Vehicles Travelling Up the Eastbound A50 exit Slip

Action Required

Mark Coney – Chair Hilton Parish Council

Appendix 1 - Image from Dashcam showing vehicle travelling up the slip road on 23/02/24

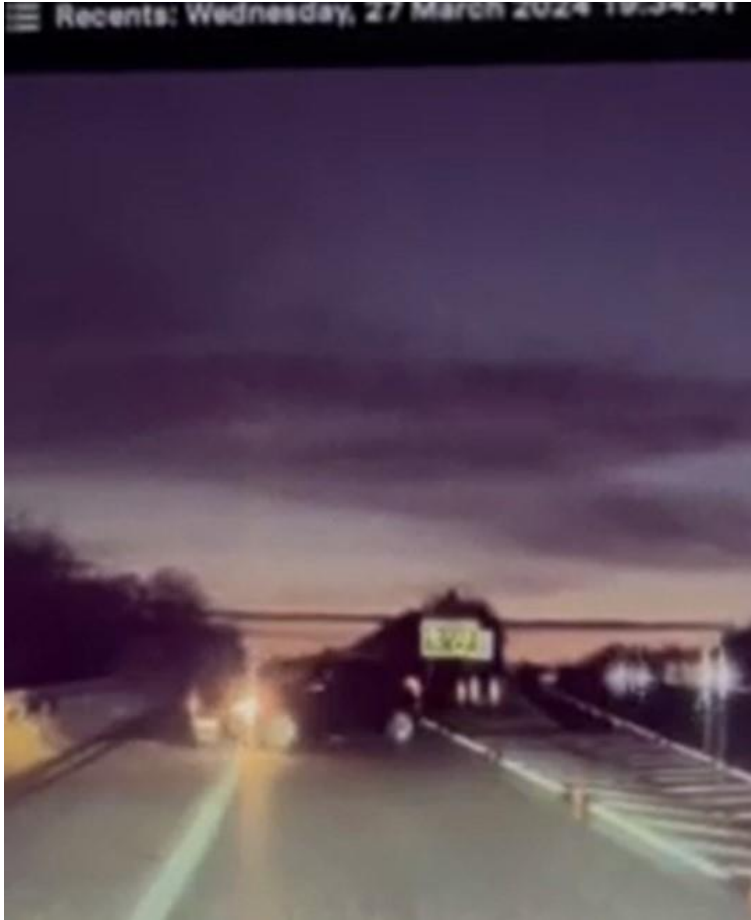
There have been an increased number of reports of vehicles travelling up the A50 Junction 5 eastbound exit slip road towards Hilton. Appendix 1 and 2 show images taken from dashcam footage on 23/02/24 and 27/03/24. Both images show a vehicle proceeding up the slip road. This is a dangerous occurrence and Hilton Parish Council is therefore concerned that an accident may occur. In the case of the footage of 23/02/24 it appears that the vehicle approaches the slip road from the Etwall direction and turns left up the slip road.

Appendix 3 – Layout of the Junction

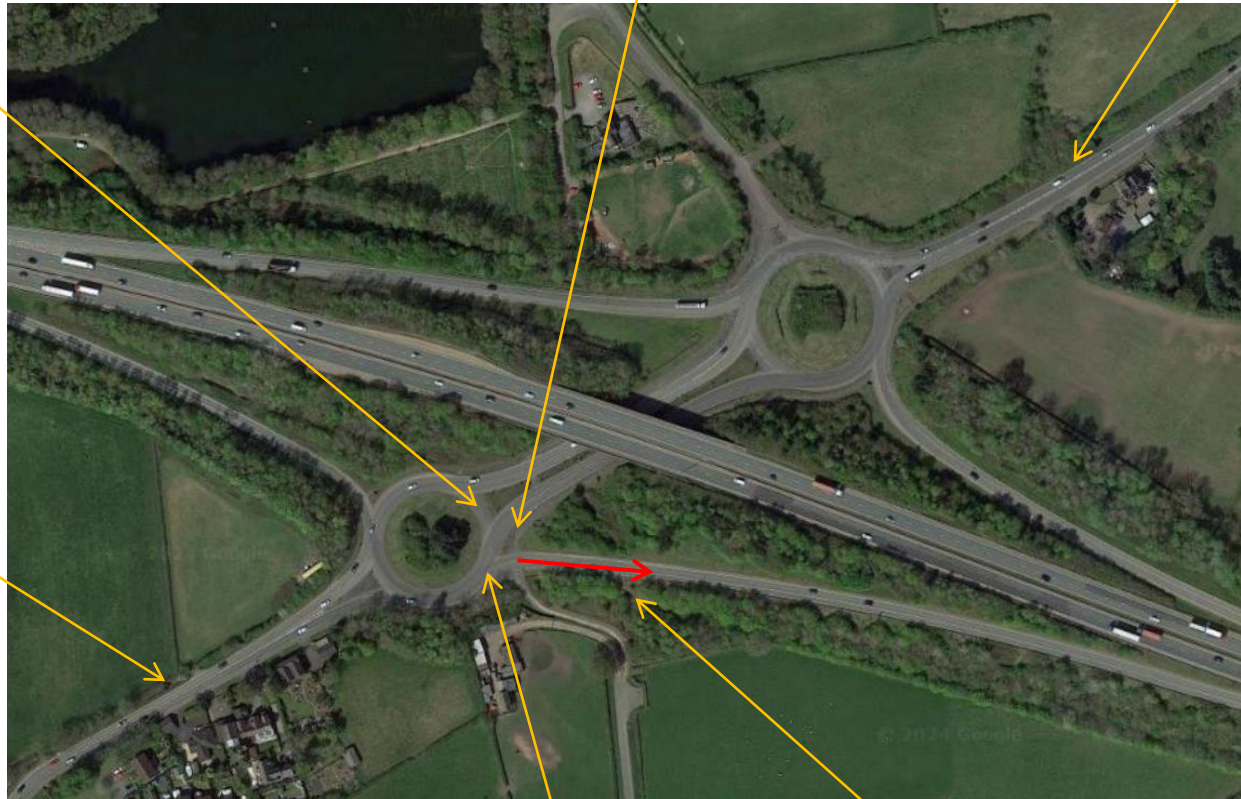
The junction provides the link between the A516, A5132 and the A50 and is configured as 2 separate but joined roundabouts below the A50. Graded slip roads link the roundabouts to the A50 in both the east and west directions. Appendix 3 shows the layout of the junction, the red arrow shows where vehicles are travelling up the slip road. The slip roads have a speed limit of 70mph.

Vehicles have been travelling Up this slip road

To prevent risk of a serious accident Hilton Parish Council is requesting that Derbyshire County Council Highways conduct a full review of the roundabout / junction including a risk assessment to understand how improvements can be made. This should be published so it can be shared with the residents of Hilton who are equally concerned. This assessment should be completed as soon as possible.
